Report to
CONSUMERS POWER COMPANY
Jackson, Michigan

SITE VISIT TO EVALUATE CRACK
REPORTED FEBRUARY 18, 1983
IN ROOF OF FEEDWATER ISOLATION VALVE
PIT UNIT 1, MIDLAND NUCLEAR
POWER PLANT

8408150695 840718
PDR FOIA
RICE84-96 PDR

CHANGE IN CRACK MAPPING
 - WEST ELECTRICAL PENETRATION AREA - NORTH FACE OF WALL AT COLUMN LINE 4
 (ELEVATION 614'-0" TO ELEVATION 613'-0")

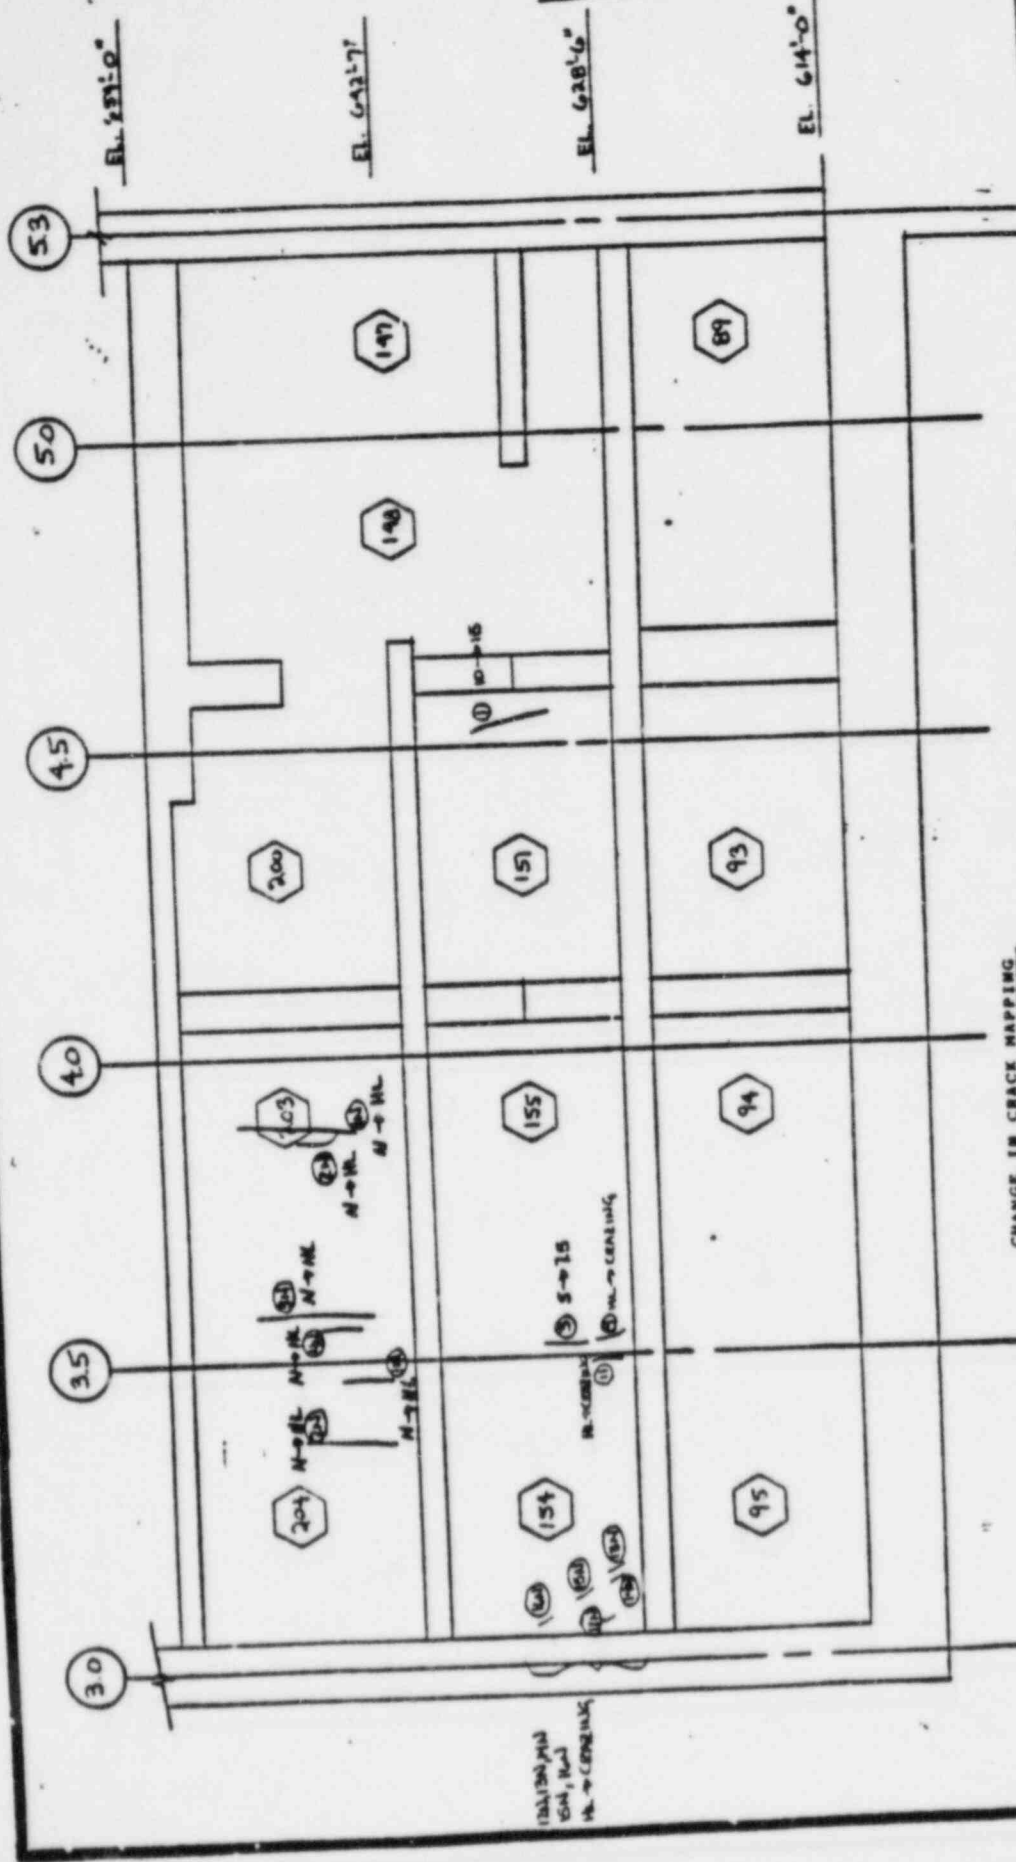
DATES MAPPED: 7/26/83 and 10/6/83
 DATE GRILLAGE JACKED: 9/18/83 LU
 AFTER INITIAL JACKING AT E/N 8/21/83

CHANGE IN CRACK MAPPING
AUXILIARY BUILDING - EAST ELECTRICAL PENETRATION AREA AT ELEVATION 859'-0"

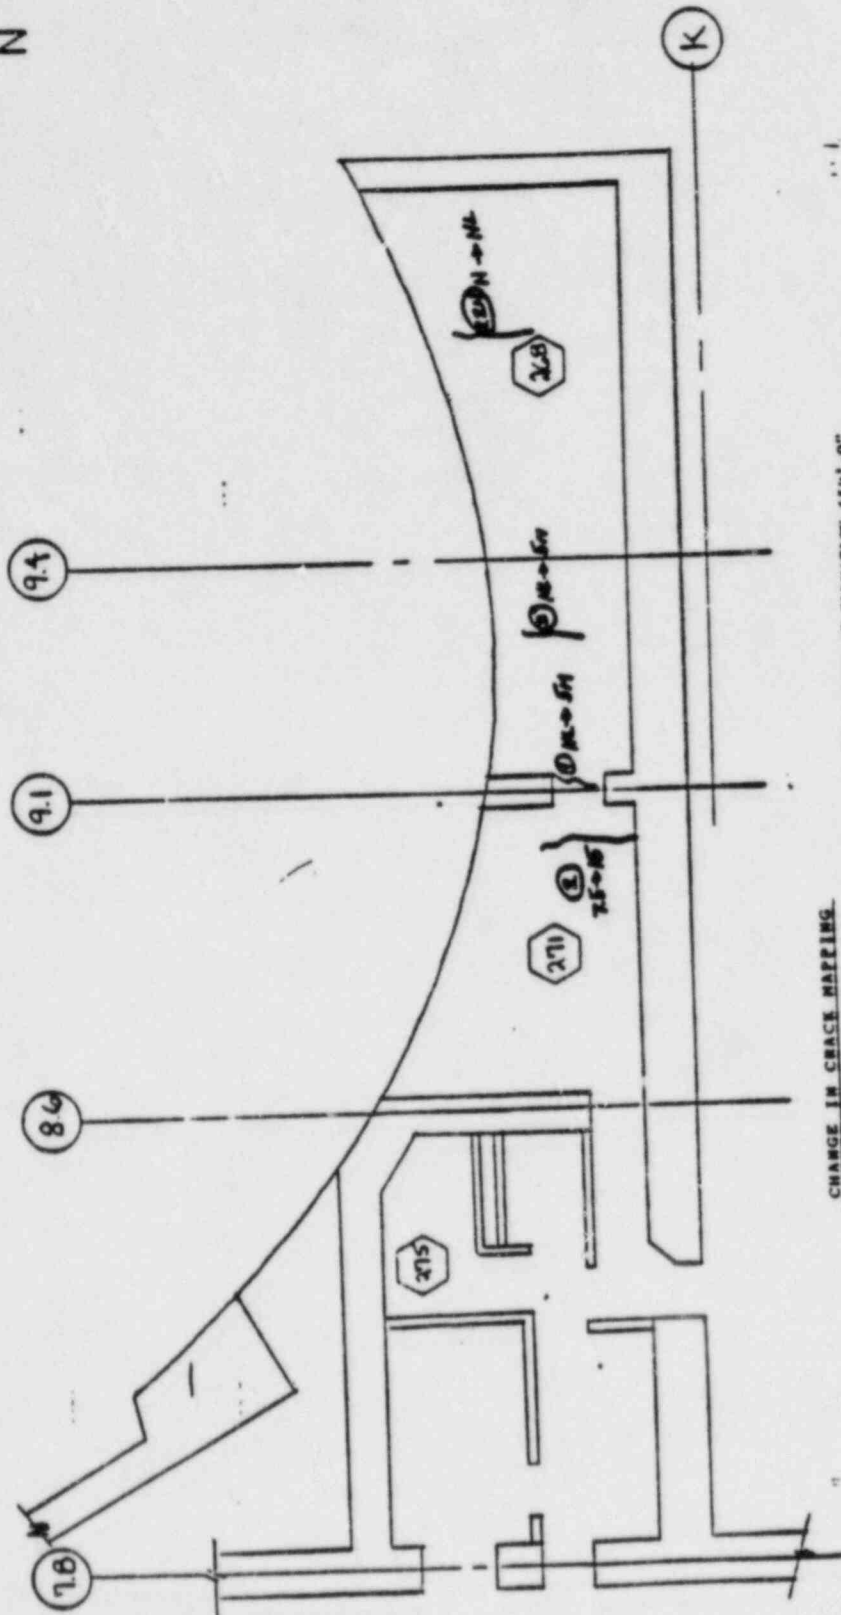
#3	HL	5	No				
		#22N	N	HL	No	5	10	No	
	271	#2	7.5	15	Yes				
East EPA Slab @674'6"	312	1	10	Crazing	N/A	10	5	No	Cracks were noted as crazing when mapped after initial jacking. Valves from 7/28/83 to 11/28/83 were within tolerance.

#11	10	Crazing	N/A	10	7.5	No	
East EPA North face of wall @ Col. Line K 614' -0" to 659' -0"	187	2N	N	HL	No				Both cracks within tolerance.
	139	1N	N	HL	No				
Control Tower West face of wall @ Col. Line 7.8	66	2N	N	HL	No				All cracks within tolerance.
		3N	N	HL	No				
	70	14	7.5	5	No
